Access Compliance Report

Public Rights-of-Way

(Curb Ramps)

Intersection ID: 30064	Main Street: CAMPUS_CONNECTION_DR	Cross Street: PAVILION_BV	Location: SE
ADA ID: DCF70616F455	Ramp Type: Perp	Initial Pass/Fail: Fail	Overall Compliance: No
Codes/Mitigation Info/Possible Solution		Field Measurements/Component Compliance	
Severity Score: 46.25

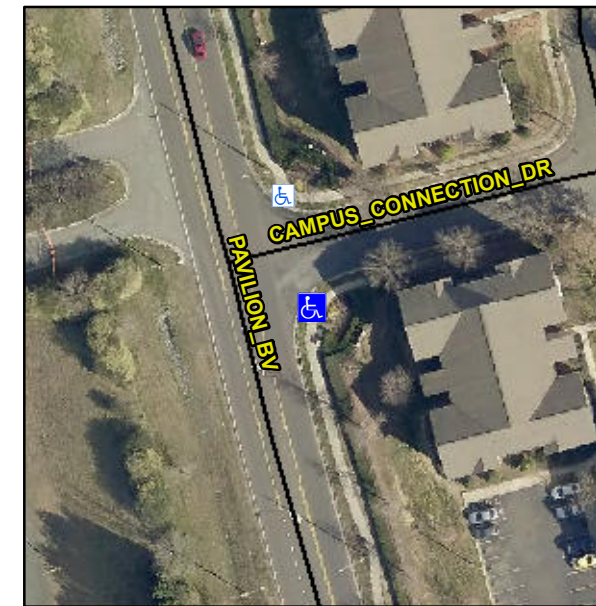
R304.5.1, R304.2.2, R304.5.3

Compliance	Description	Data	Compliance	Description	Data
N/A	Ramp Length (in)	46.0	No	Ramp Slope (%)	20.0
No	Ramp Width (in)	38.0	No	Ramp XSlope (%)	6.8
N/A	Flare Type LT	N/A	N/A	Flare Type RT	N/A
N/A	Flare Slope LT (%)	N/A	N/A	Flare Slope RT (%)	N/A
N/A	Flare Traversable LT?	N/A	N/A	Flare Traversable RT?	N/A
N/A	Landing Length (in)	N/A	N/A	DWS Provided?	N/A
N/A	Landing Width (in)	N/A	N/A	DWS Contrast?	N/A
N/A	Landing Slope (%)	N/A	N/A	DWS Length (in)	N/A
N/A	Landing X Slope (%)	N/A	N/A	DWS Full Width?	N/A
N/A	Landing Curb? (Y/N)	N/A	N/A	DWS Offset (in)	N/A
N/A	Shared Landing?	N/A			
N/A	Gutter Ponding?	N/A	N/A	Gutter Slope (%)	N/A
N/A	Gutter Lip Ht (in)	N/A	N/A	Gutter X Slope (%)	N/A
N/A	Painted X Walk1?	No	N/A	Painted X Walk2?	N/A
	X Walk 1 Direction	To N		X Walk 2 Direction	N/A
N/A	X Walk 1 Width (in)	N/A	N/A	X Walk 2 Width (in)	N/A
	X Walk 1 Slope (%)	1.5		X Walk 2 Slope (%)	N/A
	X Walk 1 X Slope (%)	8.9		X Walk 2 X Slope (%)	N/A

Remove & Replace Entire Ramp.
